SUBJECT: NuScale Power, LLC Response to NRC Request for Additional Information No. 9104 (eRAI No. 9104) on the NuScale Topical Report, "Evaluation Methodology for Stability Analysis of the NuScale Power Module," TR-0516-49417, Revision 0

NuScale Response to NRC Request for Additional Information eRAI No. 9104

Figure 1 Percent relative thermal conductivity degradation per 10 MWD/kg burnup

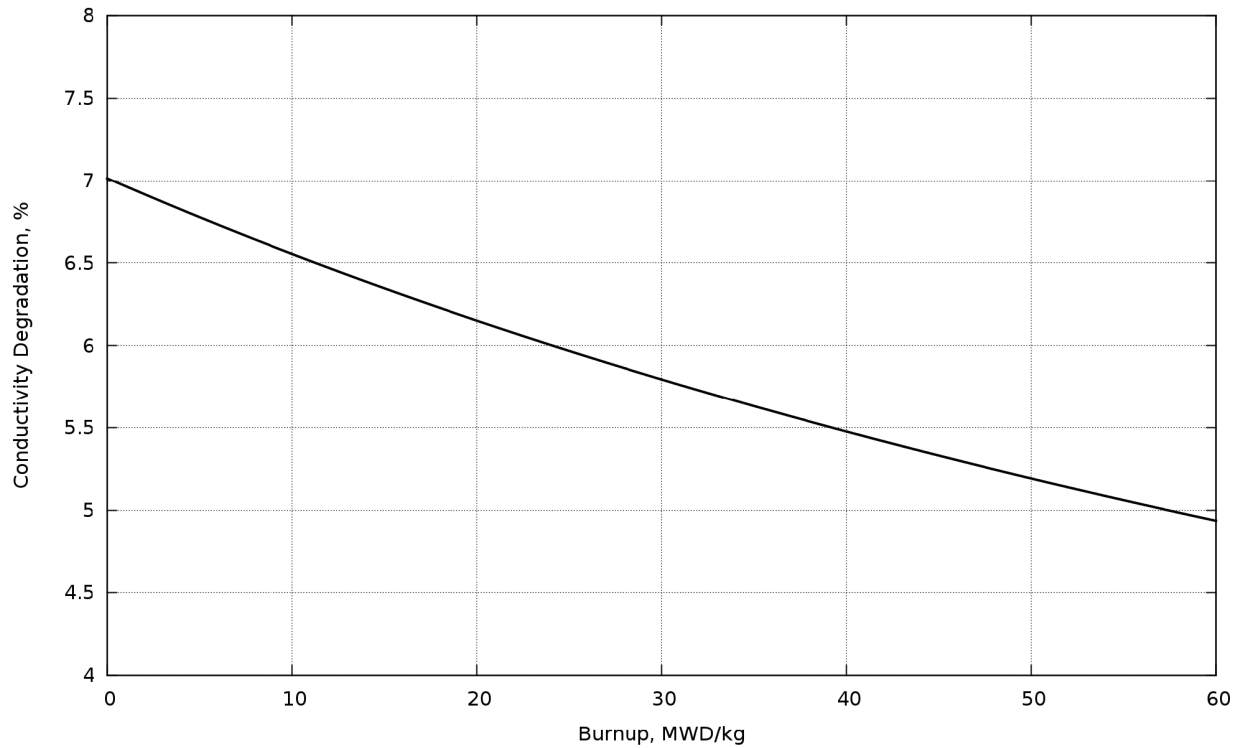
In section 5.6.4.4, "Pellet Centerline and Average Temperature," of the stability topical report, TR-0516-49417-P, describes the pellet conductivity dependence on burnup. However rationale for using the local exposure dependent fuel thermal conductivity model noted in this section (section 5.6.4.4) is requested below.

In order to make an affirmative finding NRC staff requests NuScale to provide justification of the exposure dependent fuel thermal conductivity model. It is acceptable to respond to this RAI by providing validation of the model against data.

Eqn. 5.108 for irradiated UO₂ thermal conductivity given in stability topical report TR-0516-49417-P is a simplification of Eqn. of 2.52 of FRAPCON-3.5 code report (Ref. 1). The same simple form of the thermal conductivity as function of temperature and burnup is used in Eqn. 3.3 of FRAPCON-3 report (Ref. 2) in Section 3.2 Experimental Evidence for Burnup Degradation.

In Section 3.2 of Ref. 2, experimental evidence of thermal conductivity degradation cited the Halden Ultra-High-Burnup Experiment. The experiments indicated degradation in uranium fuel thermal conductivity (averaged over the temperature range from ~750 to 1200K) of ~5 to 7%

relative per 10 GWd/MTU, for burnups up to 88 GWd/MTU. This magnitude of thermal conductivity degradation is in good agreement with the formula used in PIM as shown in Figure 1.

Figure 1 is a plot of the percent relative decrease of thermal conductivity per 10 MWD/kg burnup at a temperature of 900 K, versus burnup. The relative degradation is obtained directly from Eqn. 5.108 of the TR as:

Figure 1 shows the percent relative degradation in the correct experimental range of ~5 to 7%.
